A d d e n d u m

Iowa Department of Transportation
Office of Contracts

B.O.	Proposal ID	Proposal Work Type	County	Project Number	Addendum
014	43-1831-041	BRIDGE REPLACEMENT - PPCB	HARRISON	BRFN-183-1(41)--39-43	17DEC014.A03

Replace Sheets Q.3 & Q.4 with the attached Sheets Q.3 & Q.4.

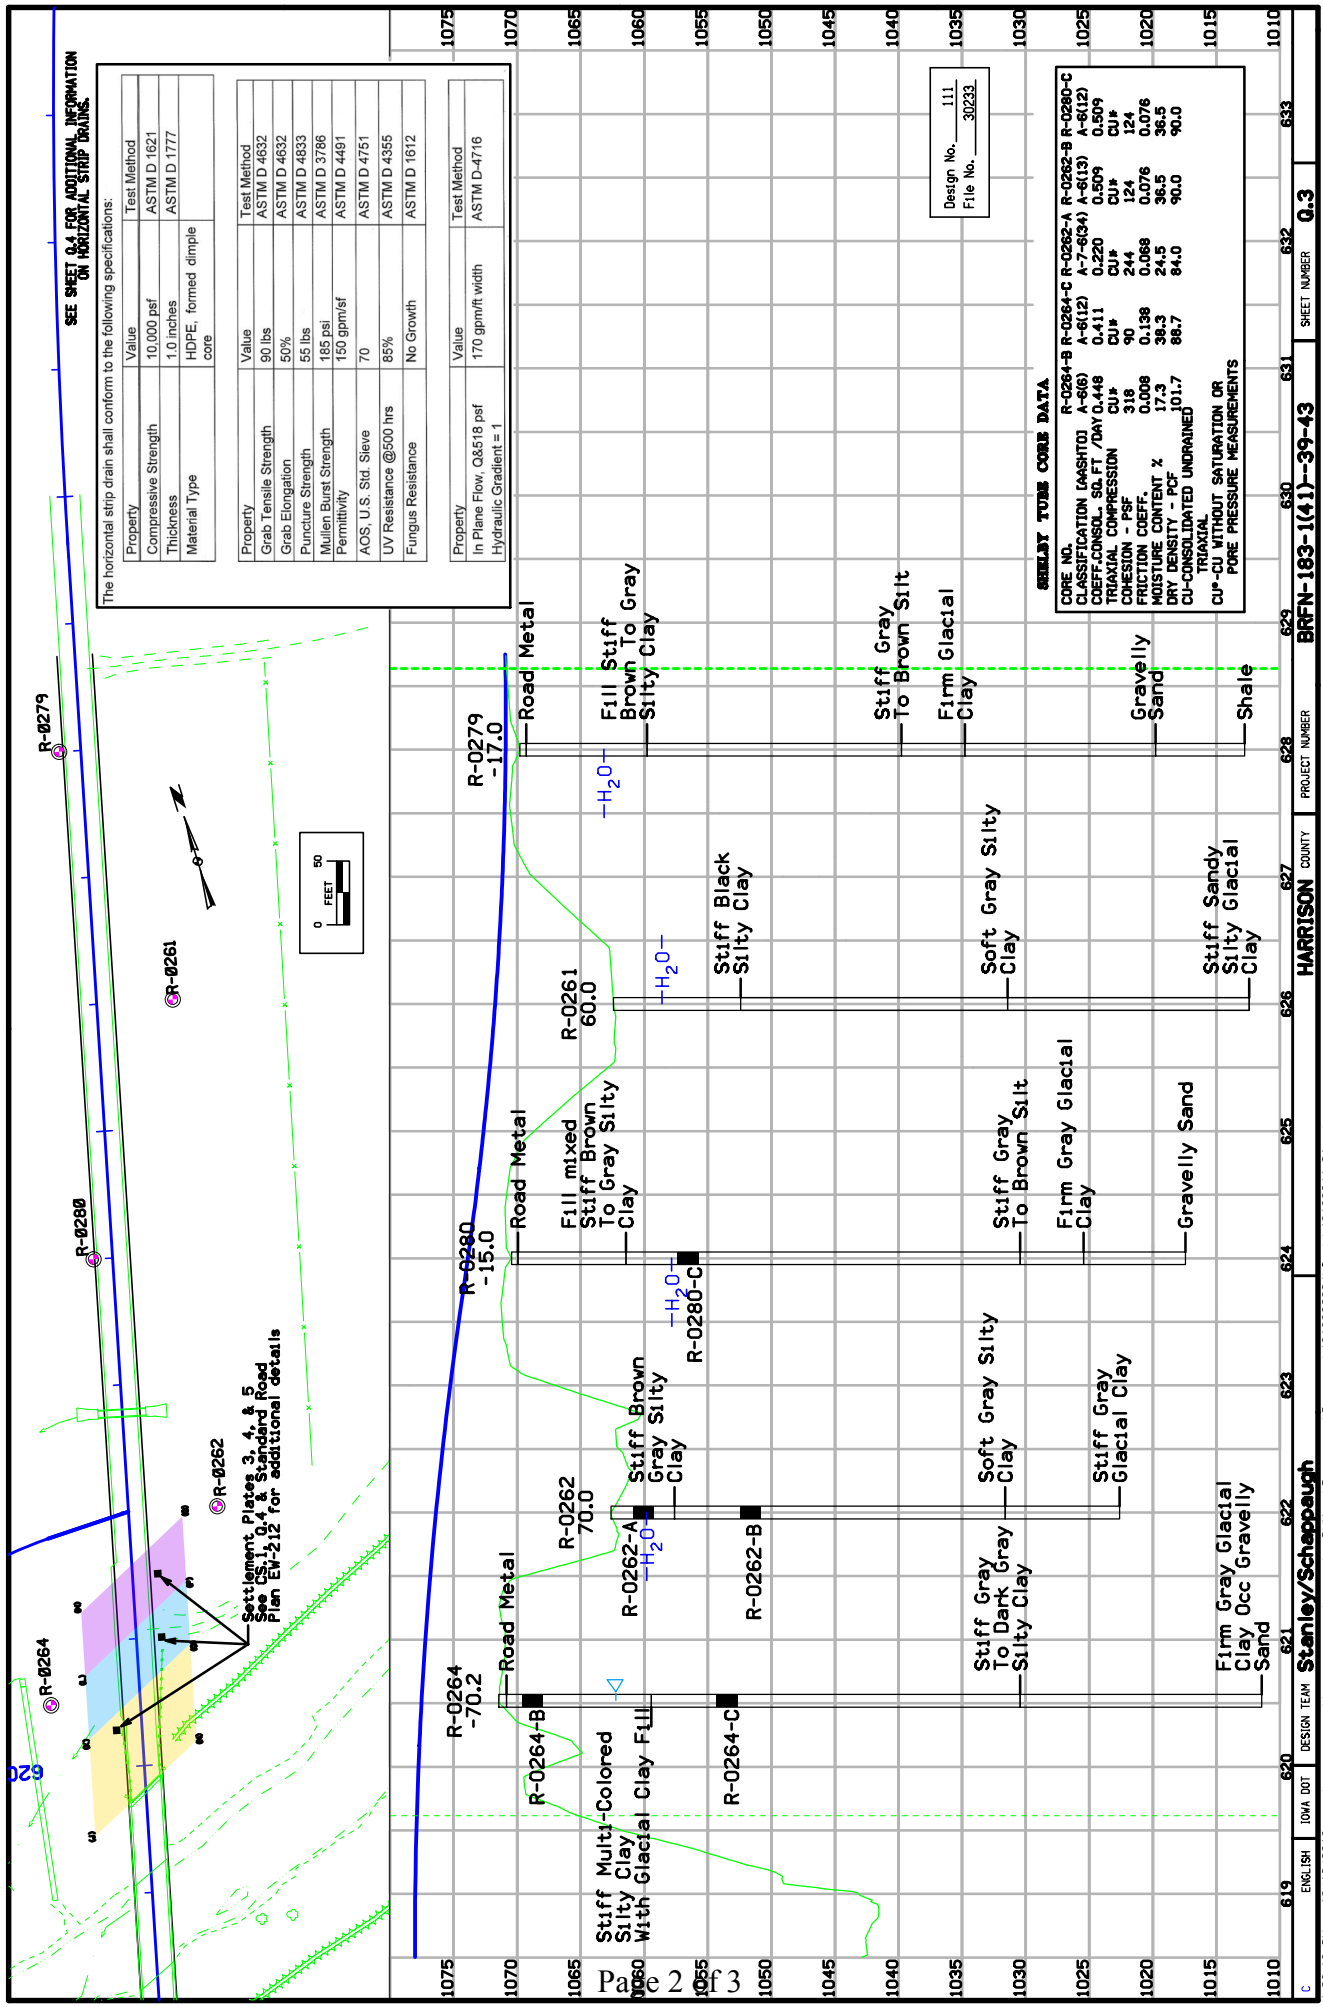
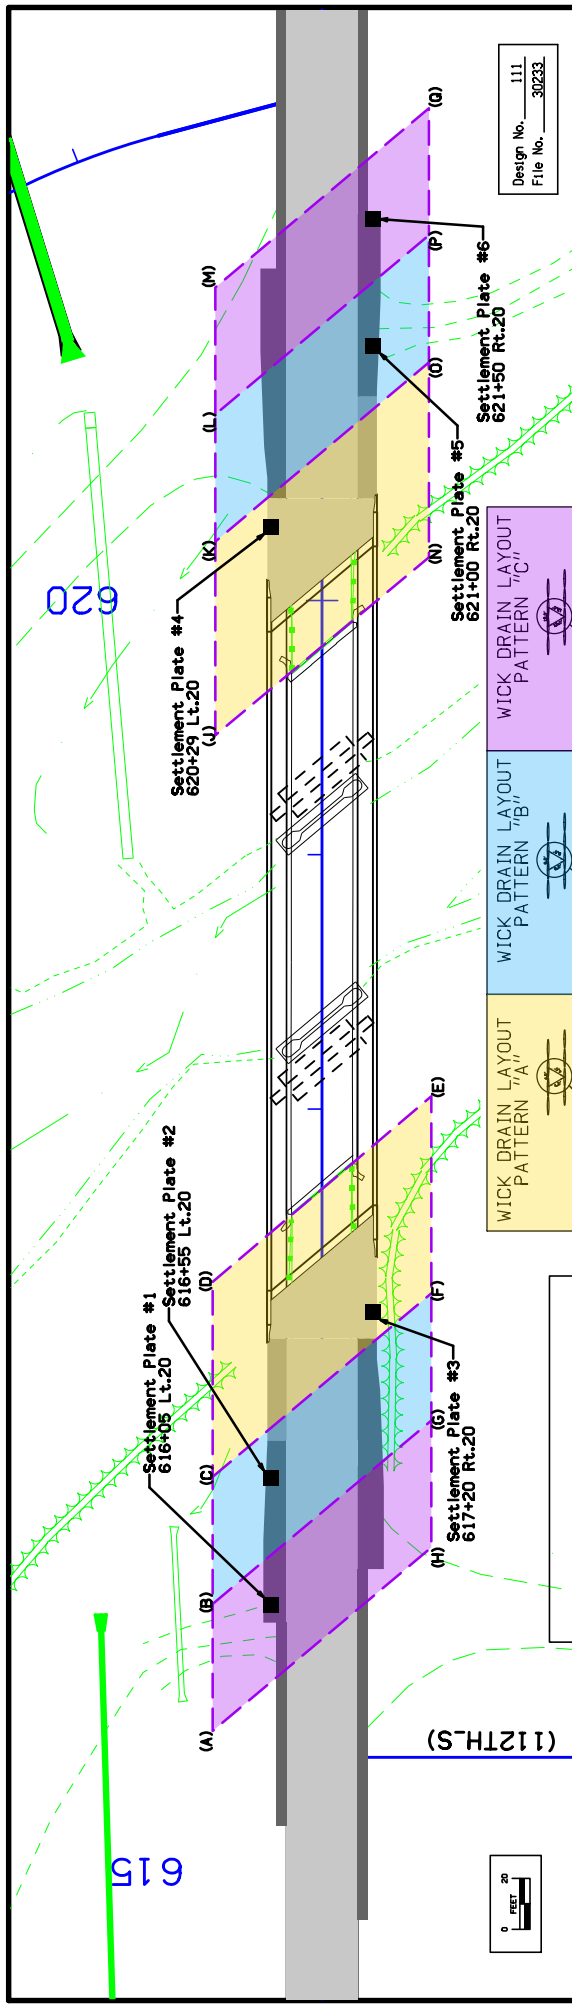
Add Proposal Line No. 0215 2112-0000100 WICK DRAIN: LF 62,873.000

Add Proposal Line No. 0595 2599-9999009 ('LINEAR FEET' ITEM) HORIZONTAL STRIP DRAIN: LF 9,700.000

2599-9999009 ('LINEAR FEET' ITEM) HORIZONTAL STRIP DRAIN

Refer to Sheets Q.3 and Q.4 for locations and details.

Method of Measurement: Lineal feet as installed according to the contract documents, calculated from measurements of installed lengths.

Basis of Payment: Payment for horizontal strip drain will be the contract unit price per lineal foot. Payment includes all labor, equipment, and materials necessary to complete the installation according to the contract documents. No payment will be made for unacceptable drain or trial drain installations.

SEE SHEET 6.4 FOR ADDITIONAL INFORMATION ON HORIZONTAL STRIP DRAINS.

The horizontal strip drain shall conform to the following specifications:

Property	Value	Test Method
Compressive Strength	10,000 psf	ASTM D 1621
Thickness	1.0 inches	ASTM D 1777
Material Type	HDPE, formed dimple core

Property	Value	Test Method
Grab Tensile Strength	90 lbs	ASTM D 4632
Grab Elongation	50%	ASTM D 4632
Puncture Strength	55 lbs	ASTM D 4633
Mullen Burst Strength	185 psi	ASTM D 3786
Permittivity	150 gpm/ft	ASTM D 4491
AOS, U.S. Std. Sieve	70	ASTM D 4751
UV Resistance @500 hrs	85%	ASTM D 4355
Fungus Resistance	No Growth	ASTM D 1612

Property	Value	Test Method
In Plane Flow, 0.8518 psf Hydraulic Gradient = 1	170 gpm/ft width	ASTM D-4716

Grade in stationing shall be necessary for prefabricated vertical (wick) drains in stationing. It will be incidental to the wick and horizontal drain system installation.

See Section 2112 Standard Specification Series 2012 for Wick Drains. The sand blanket discussed in Section 2112 shall be installed as approved by the Engineer. After installation, cut off the wick drains a minimum of 12 inches above ground level, but long enough to contact with and overlap the prefabricated horizontal (strip) drains. Prefabricated horizontal (strip) drains shall be used to convey wick water beyond the embankment boundaries. See Sheet 0.3 for strip drain specifications. Nominal horizontal strip drain thickness shall be approximately 1 inch. Nominal strip drain width shall be 6 inches or wider. Install the horizontal drains on the ground surface in rows laid out in a triangular pattern. Secure the horizontal drain material in position at each wick drain by staking, nailing, or by the manufacturer's recommended method. Extend the horizontal drains to final ditch locations left and right. Follow the material manufacturer's recommendations to make any necessary splice and bedding connections. There is an estimated 9,700 lineal feet of horizontal drain needed.

Build the embankment over the drainage system, placing initial soil lifts by methods recommended by the drain manufacturers to prevent damage to the drains.

From Station 615+50, Left 43, to Station 618+05, Right 43, and from Station 619+47, Left 42, to Station 620+23, Right 42, install prefabricated vertical (wick) drains in a triangular pattern with center-to-center spacings shown in Table 2 and the three details (see left), surface to the estimated tip elevations shown in Table 2. There is an estimated 62,873 lineal feet of vertical wick drains needed. The Contractor should be aware that because of the stiffness of some soils layers, variability in soil material types and the depths to be penetrated. See the blow counts in the boring logs on sheet accordance with Iowa DOT Specification 2112 for Wick Drains (except no sand blanket is needed for drainage), which requires additional soil borings by the contractor.
